BCA COMPLIANCE ASSESSMENT REPORT

Project: Bathroom and Laundry Refurbishment Valley Terminal Building Thredbo.

REPORT NO: 22116B

Class 3 Accomodation

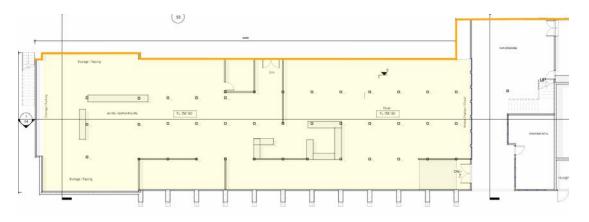
The walls, ceilings and floor marked up below will need to be upgraded with fire rated plasterboard.

- External Wall (3m to 9m adjoining Building) FRL 90/30/30.
- Fire Wall Separating Compartments
 FRL90/90/90
- --- Internal Walls between Units and Corridor FRL60/60/60

RISF of 60 minutes

External Wall (3m to 9m adjoining Building) FRL 180/90/60.

(Note: CSR does not provide a fire rated plasterboard solution for this FRL. Alternative products will need to be sourced.)

Ceiling.
(Internal walls to extend to the underside of the floor with FRL30/30/30 (including

Loadbearing Columns

FRL180/-/-

(Note: CSR does not provide a fire rated plasterboard solution for this FRL. Alternative products will need to be sourced.)

Refer to the specifications from CSR outlined in Appendix 1 of this report on how to achieve the required Fire Resistance Levels (FRL's)

APPENDIX 1: FIRST FLOOR - FIRE SEPARATION

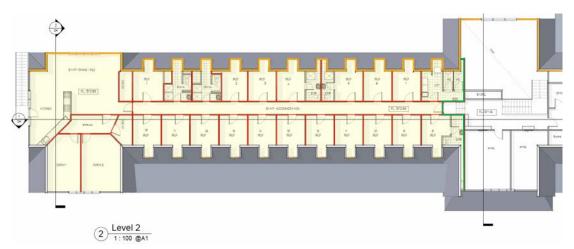
- **External Wall** (3m to 9m adjoining Building) FRL 90/30/30.
- Fire Wall Separating Compartments FRL90/90/90
- Internal Walls between Units and Corridor FRL60/60/60

(Internal walls do not extend to underside of roof sheeting)

RISF of 60 minutes

SYSTEM SPECIFICATION		
FRL Report/Opinion	SYSTEM N°	WALL LININGS
60/60/60 90/90/90* (from both sides) *ACR 15% FC 12946	CSR 5168	EXTERNAL WALL SIDE 1 x 16mm Gyprock Fyrchek MR Plasterboard. INTERNAL WALL SIDE 1 x 16mm Gyprock Fyrchek Plasterboard.

FRL Report/Opinion	SYSTEM N°	CEILING LININGS
60/60/60 +RISF 60 minutes EWFA 26162	CSR 6430	1 x 13mm Gyprock Fyrchek Plasterboard. 1 x 16mm Gyprock Fyrchek Plasterboard (any order).

FRL Report/Opinion	SYSTEM N°	WALL LININGS
-/120/120 90/90/90 FAR 2303	CSR 2090	BOTH SIDES • 2 x 13mm Gyprock Fyrchek Plasterboard.

FRL Report/Opinion	SYSTEM N°	WALL LININGS
-/60/60	CSR 2070	BOTH SIDES
60/60/60 FAR 2303		1 x 16mm Gyprock Fyrchek Plasterboard.

GROUND FLOOR - FIRE SEPARATION

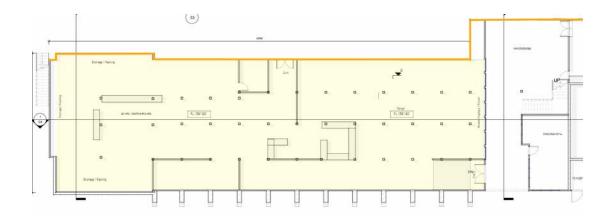
External Wall (3m to 9m adjoining Building) FRL 180/90/60.

(Note: CSR does not provide a fire rated plasterboard solution for this FRL. Alternative products will need to be sourced.)

Loadbearing Columns FRL180/-/-

(Note: CSR does not provide a fire rated plasterboard solution for this FRL. Alternative products will need to be sourced.)

2 layers 13mm fire rated plasterboard has been provided to common corridor. (To be confirmed installed to entire corridor)

2 layers of 16mm Fire Rated Plasterboard has been provided to Corridor Ceiling. (To be confirmed installed to entire corridor)

The walls and ceilings of the accommodation rooms have not been provided with fire separation.

Separating wall to achieve FRL90/90/90 or Fire Engineered Performance Solution to be Developed.

FRL Report/Opinion	SYSTEM N°	CEILING LININGS
30/30/30 +RISF 30 minutes EWFA 26162	CSR 6030	1 x 16mm Gyprock Fyrchek Plasterboard.
